Duke Power Company
Oconee Nuclear Station

Attachment 1

Proposed Technical Specification Revision

Discussion of Proposed Technical Specification Revisions

Figure 6.1-2

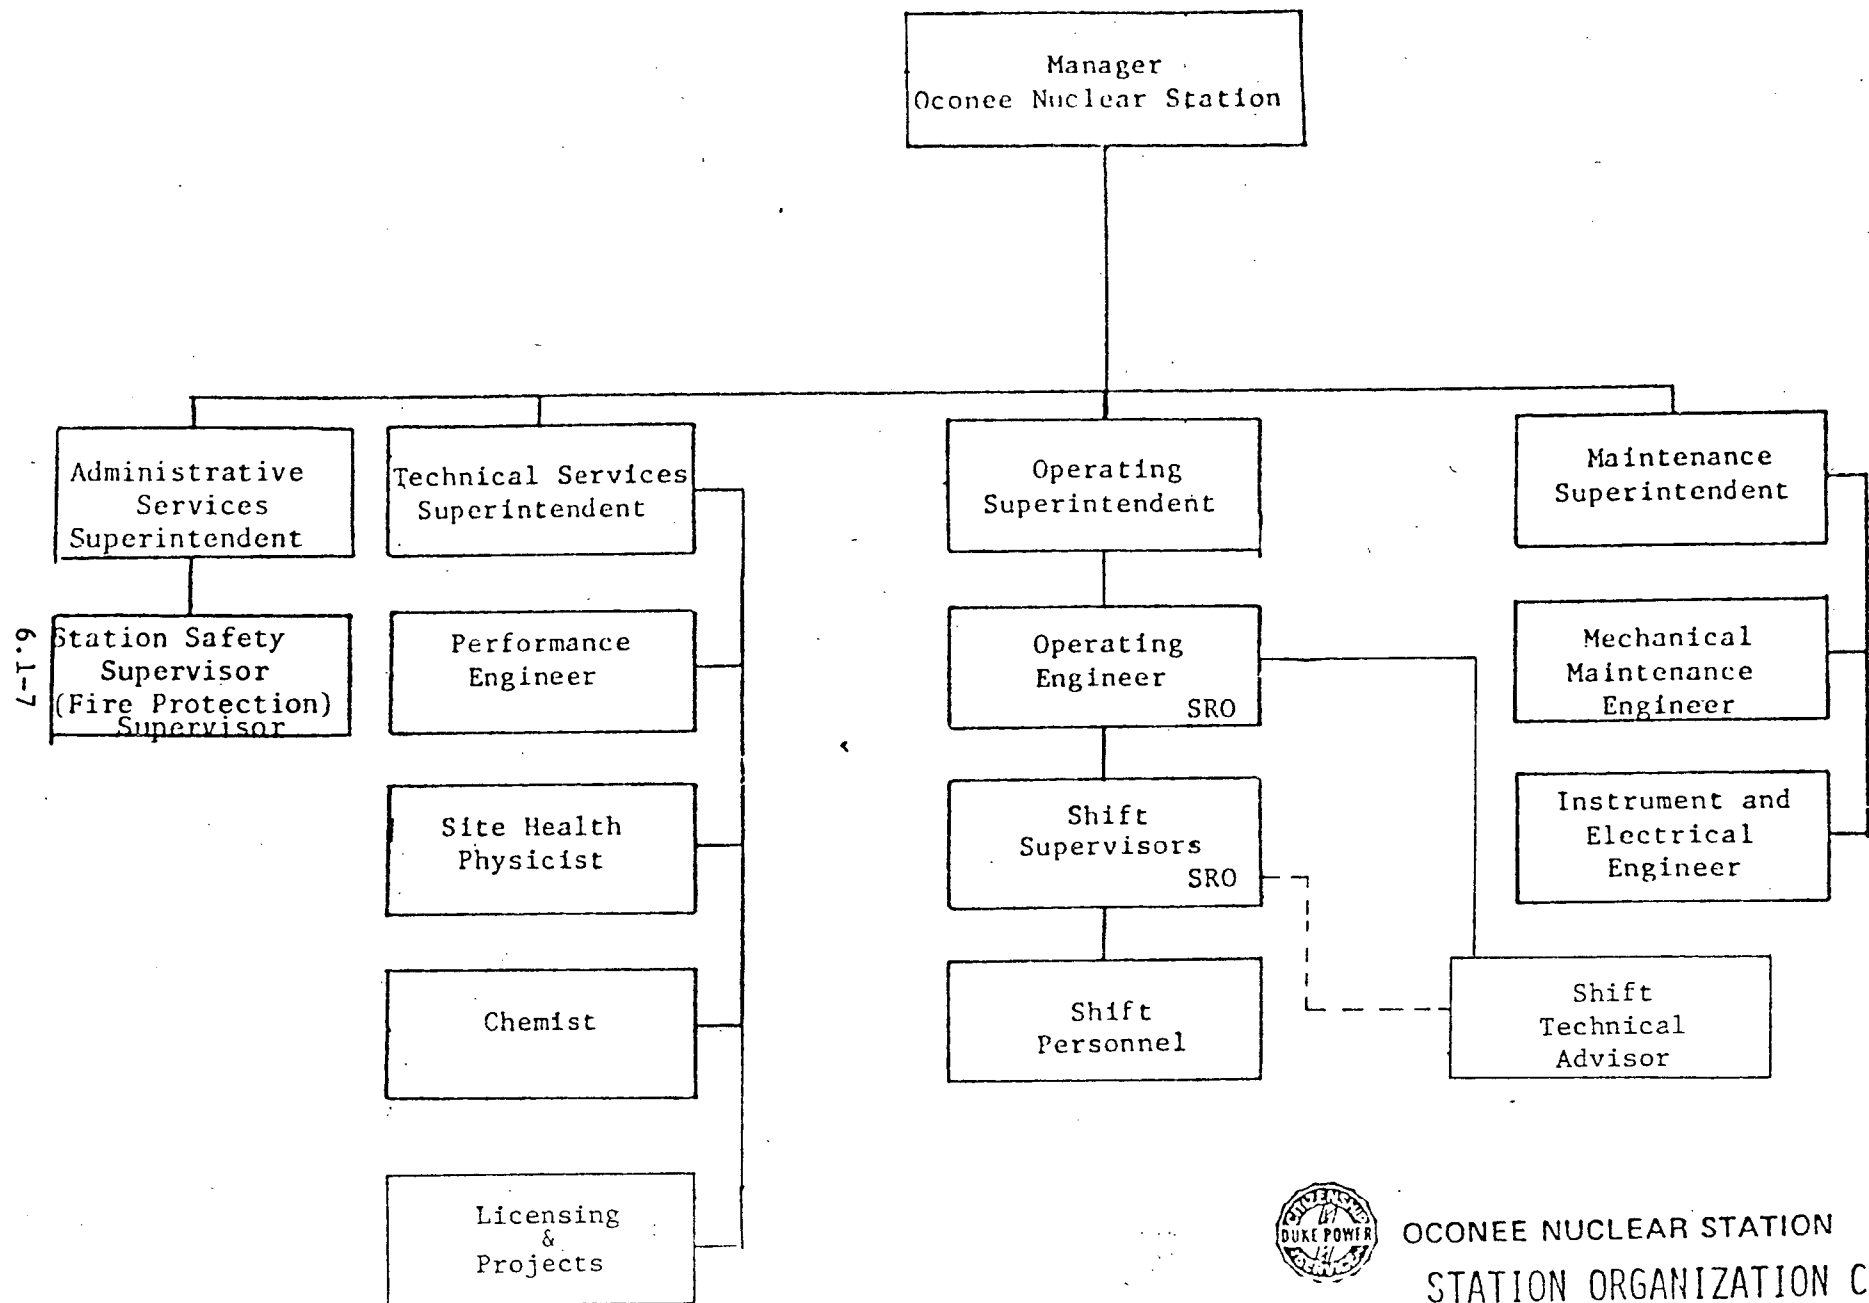
As of August 1, 1982 Duke Power Company will reorganize the Steam Production Department into three separate departments along functional lines: Nuclear Production Department, Fossil Production Department, and Production Support Department. The Nuclear Production Department will be organized as indicated in the diagram which is attached for your information. The changes proposed in the Technical Specifications mainly involve the title changes to be incorporated into the reorganization.

- 6.1.1.2 In all matters pertaining to actual operation and maintenance and to these Technical Specifications, the station Manager shall report to and be directly responsible to the Vice President, Nuclear Production Department, through the General Manager, Nuclear Stations. The organization is shown in Figure 6.1-2.

OCONEE NUCLEAR STATION
STATION ORGANIZATION CHART
FIGURE 6.1-1

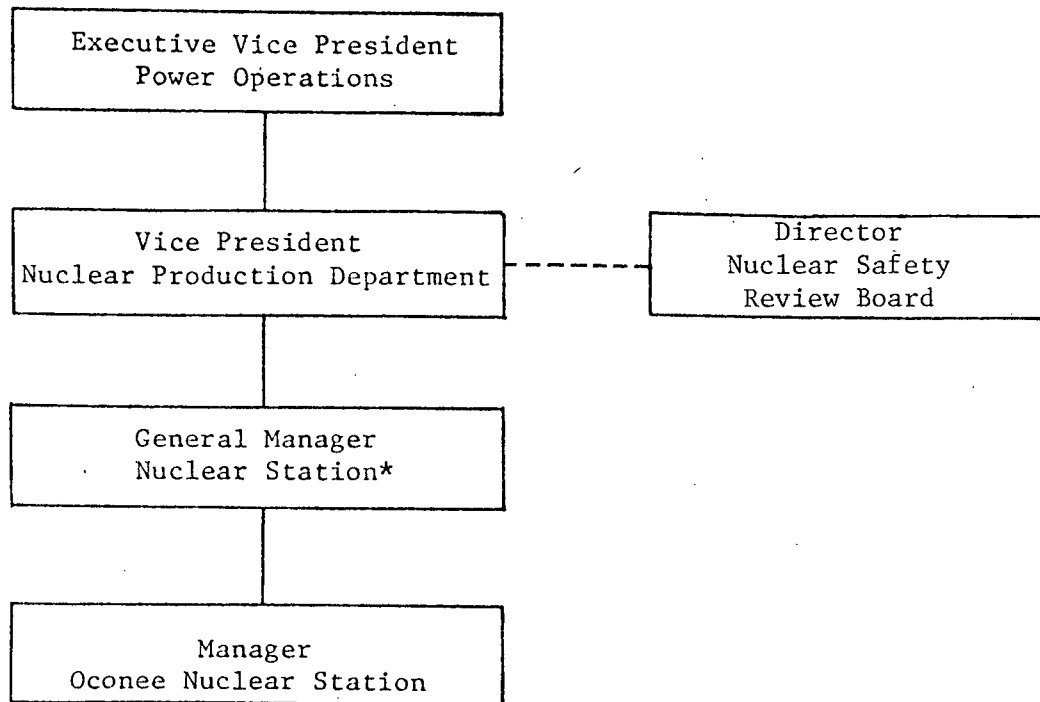
The organizational chain with plant operations has been revised in Figure 6.1-1. Under the proposed revision the Shift Supervisors report to an Operating Engineer. The Operating Engineers have the responsibility for directing the actual day-to-day operation of the units. The Operating Engineers report to the Superintendent of Operations who has the responsibility for operation of all Oconee Nuclear Station units. The requirement for the Superintendent of Operations to maintain a Senior Reactor Operator license has been deleted.

Within the multi-unit Oconee Nuclear Station, an Operating Engineer, as the direct supervisor of the Shift Supervisors, will have and maintain a Senior Reactor Operator license. However, the duties of the Superintendent of Operations do not require him to maintain a Senior Reactor Operator license, and the training required to maintain this license actually detracts from time that should be spent in managing the overall operations of the multi-unit Oconee Nuclear Station. This organization chart and the Senior Reactor Operator license requirements will be consistent with other Duke Power Company nuclear stations.

- 6.1.1.3 The station organization for Operations, Technical Services and Maintenance shall be functionally as shown in Figure 6.1-1. Minimum operating shift requirements are specified in Table 6.1-1.
